PCN# 20130909000B
Qualification of selected TSSOP devices in TI Malaysia
Change Notification / Sample Request

PCN Number:	20130909000B	**PCN Date:**	06/16/2014

Title:	Qualification of selected TSSOP devices in TI Malaysia

Sample roduct shipping label (not actual product label)

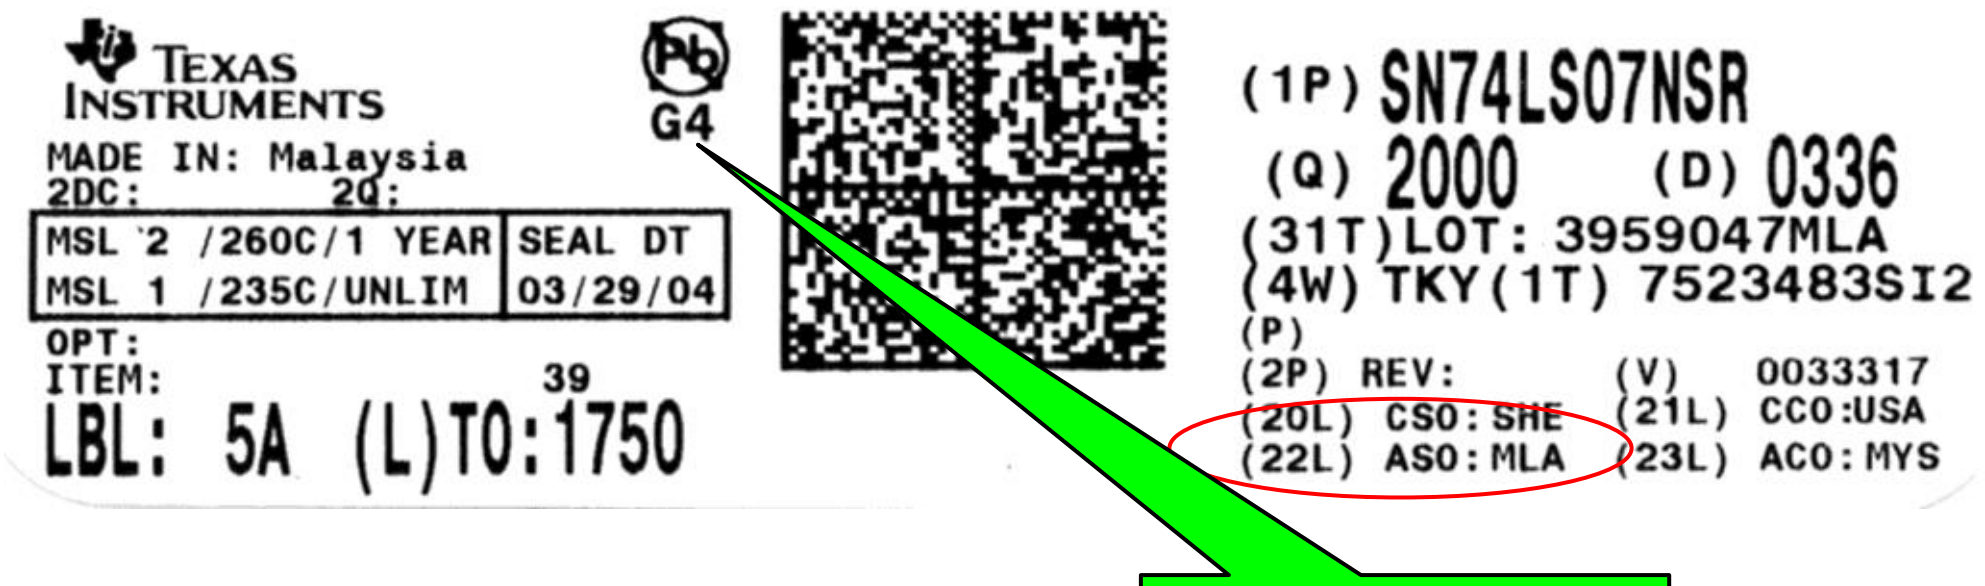
Changes to product identification resulting from this PCN:

Assembly Site		
TI Melaka	Assembly Site Origin (22L)	ASO: CU6
Unisem	Assembly Site Origin (22L)	ASO: UNM
TI Malaysia	Assembly Site Origin (22L)	ASO: MLA

G4 = NiPdAu
G3= MATTE Sn

Topside Device marking:
Assembly site code for TI Melaka = U
Assembly site code for Unisem = H
Assembly site code for TI Malaysia = K
